AUXILIARY FEEDWATER FLOW

(177 FA PLANTS)

86-1102587-00

11. You have committed to provide a new Limiting Condition for Operation (LCO) in the plant technical specifications requiring an EFW flow path to each steam generator be available at 100% capacity. Your commitment states:

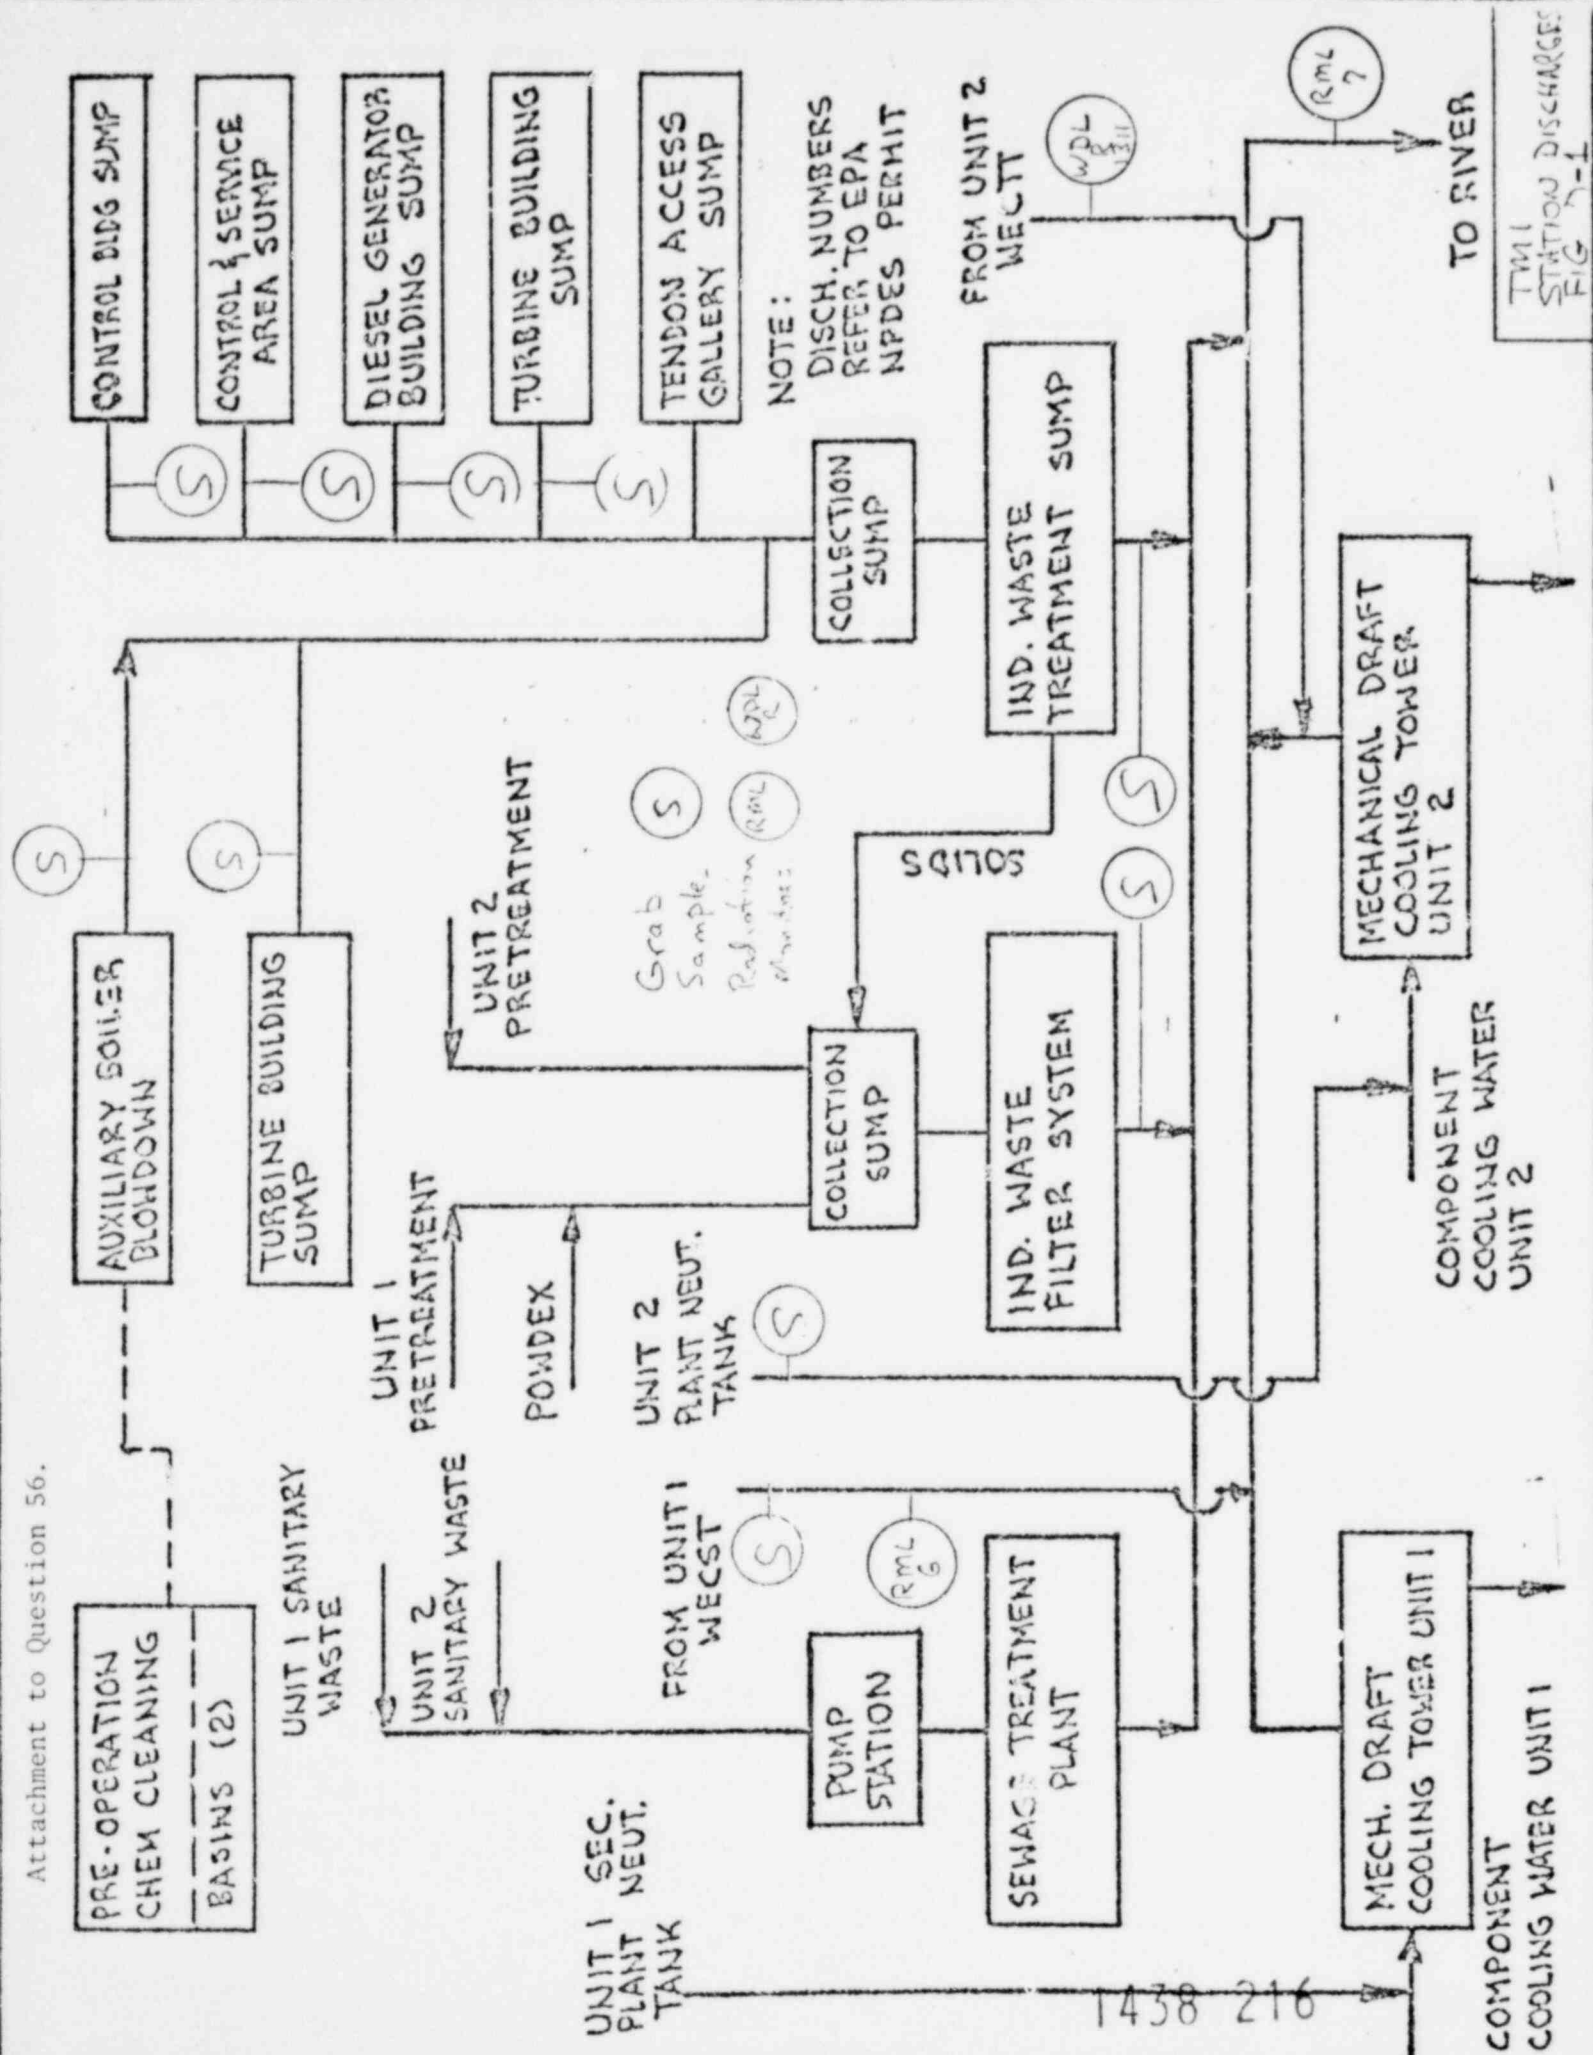
56. Provide revised Figure 7-1 "Station Discharge" indicating sample points, in-line radiation monitors, and applicable unit numbers on the equipment.

See revised Figure 7-1.

Figure 5.2.1

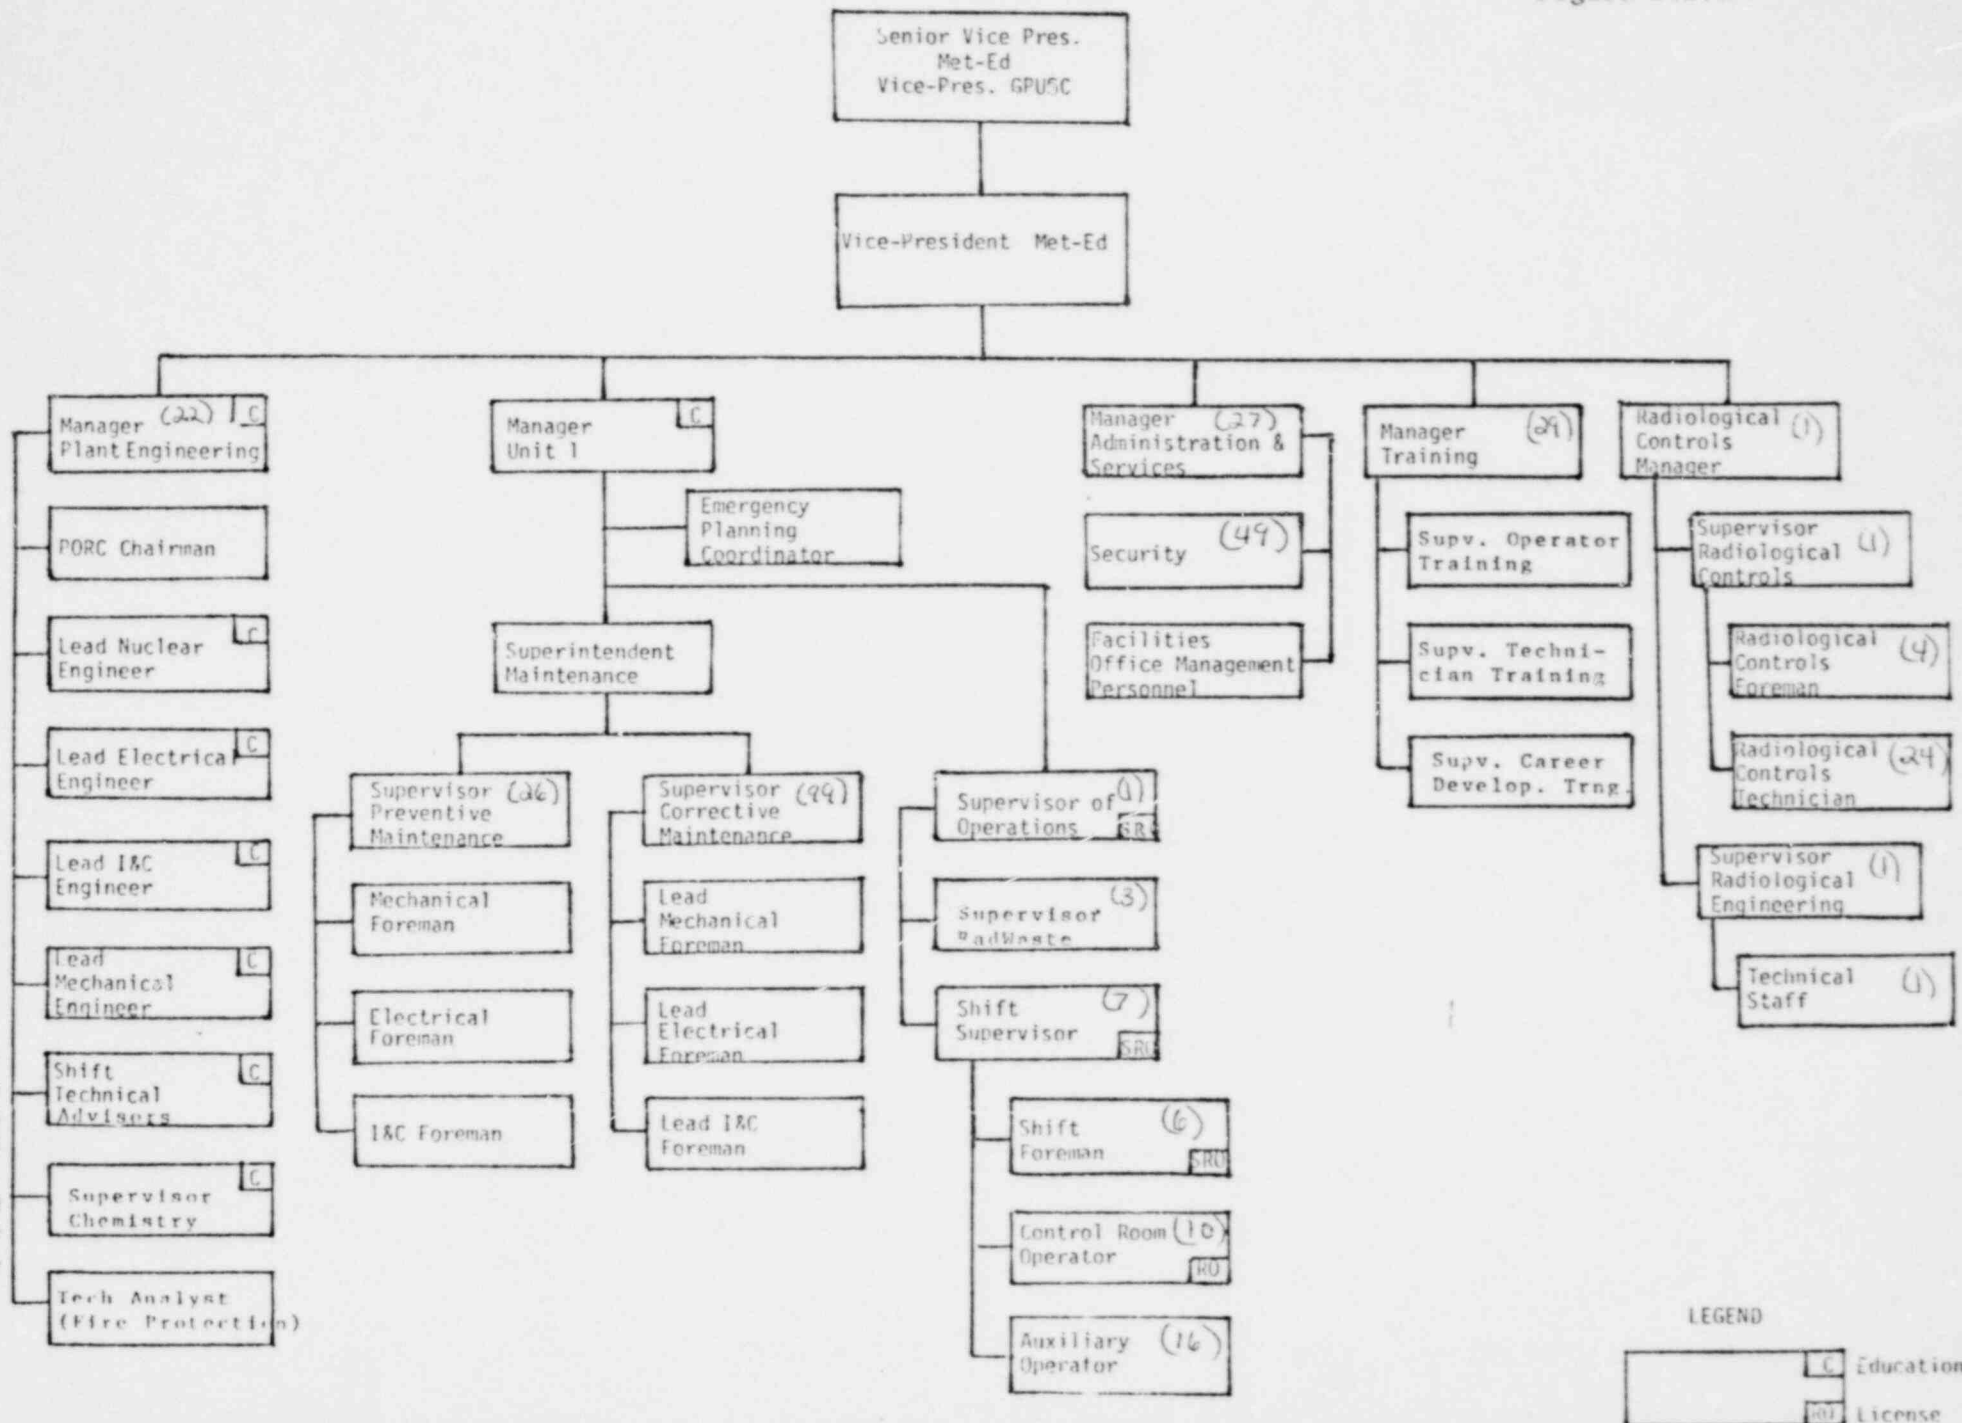
63. Expand Figure 5.2-1 to show details down to the technician level. Include qualification requirements for all functional blocks except those in the Manager Support Services and Logistics.

See numbers in () on attached figure.

ON-SITE EMERGENCY ORGANIZATION
Figure 12

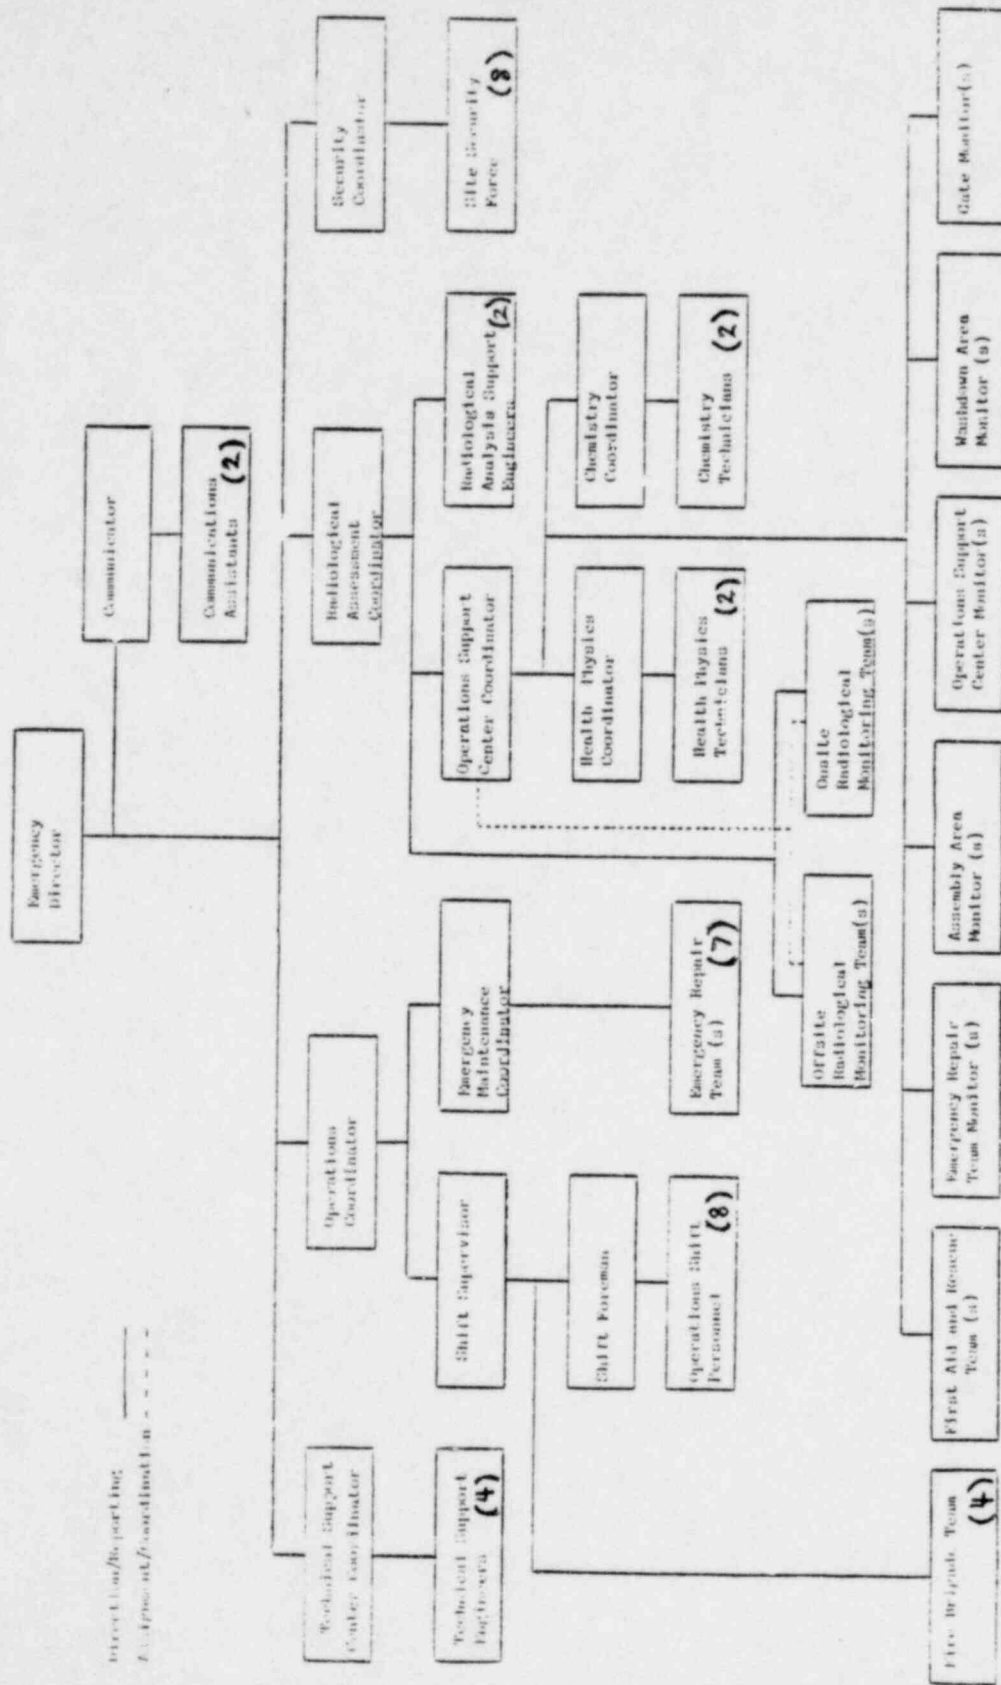
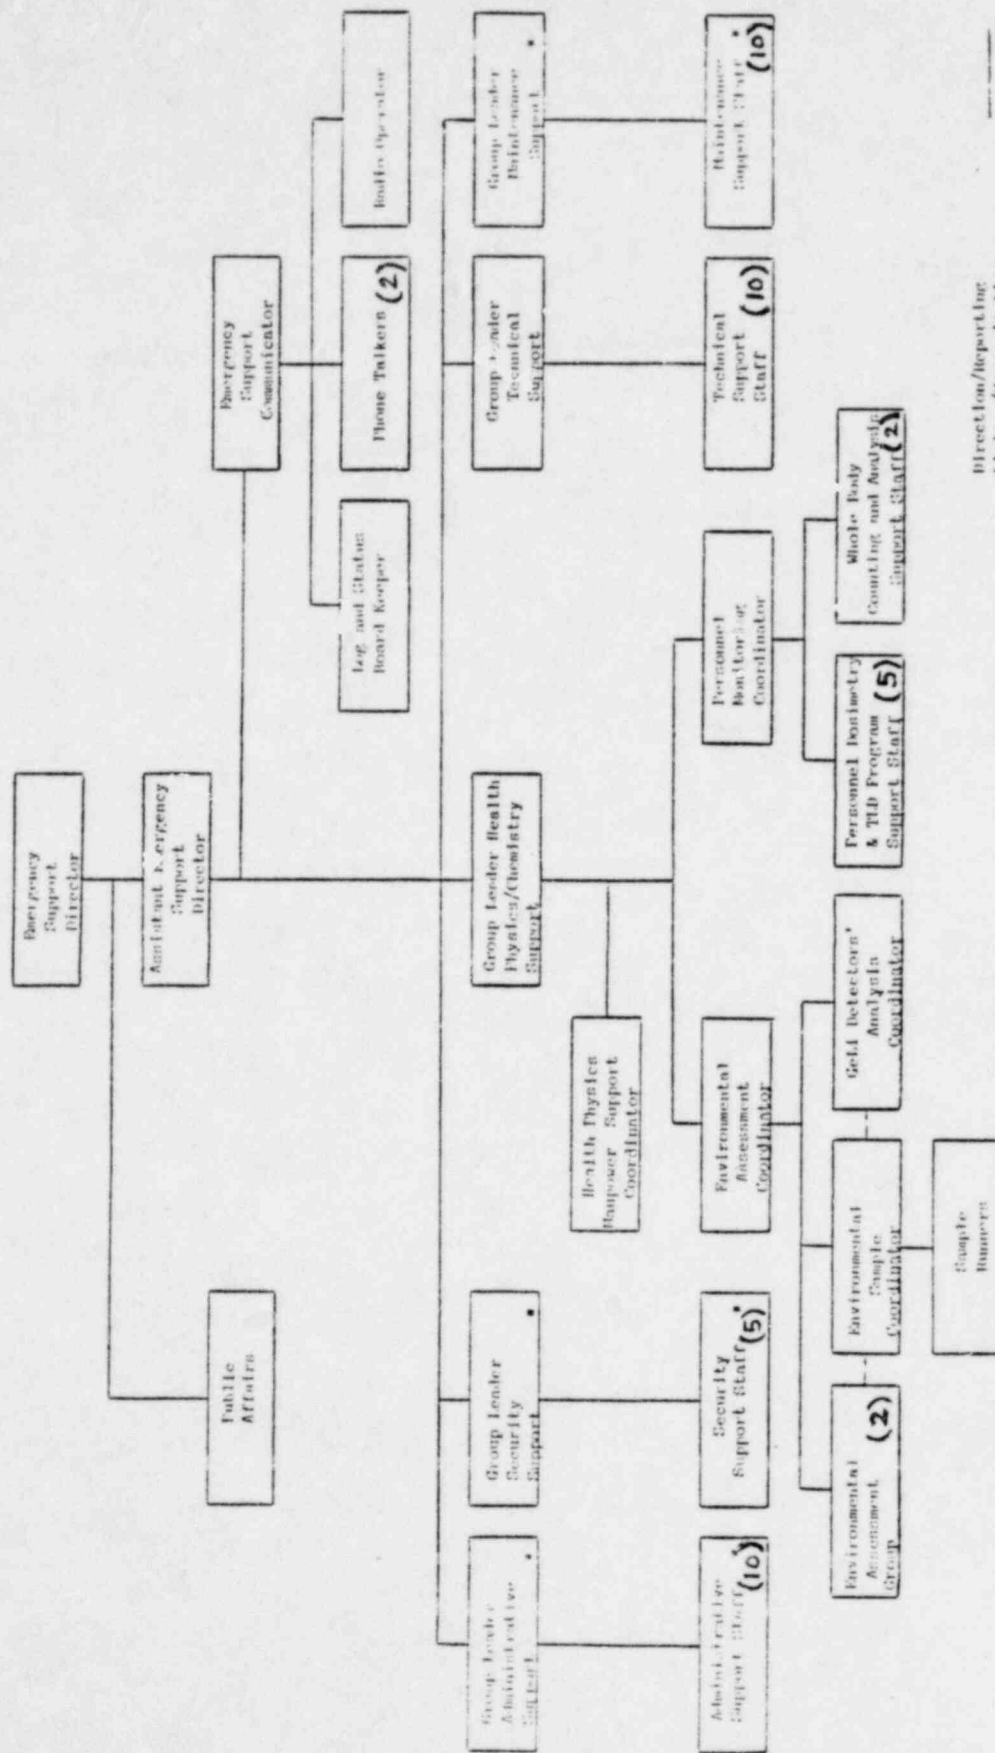
82. Describe the number of persons you plan to assign to each of the functional blocks shown in Figures 12 and 13.

The duty section concept for staffing figure 12 is discussed in the answer to Question 86. For the functional blocks where more than one individual is required, the annotated Figure 12 is attached. The number in () indicates the average number of personnel expected to be assigned.

The staffing of Figure 13 will be accomplished by designating a primary and two alternate individuals to each of the key supervisory positions. For those functional blocks where more than one individual is required, the annotated Figure 13 is attached. The number in () indicates the average number of personnel expected to be assigned.
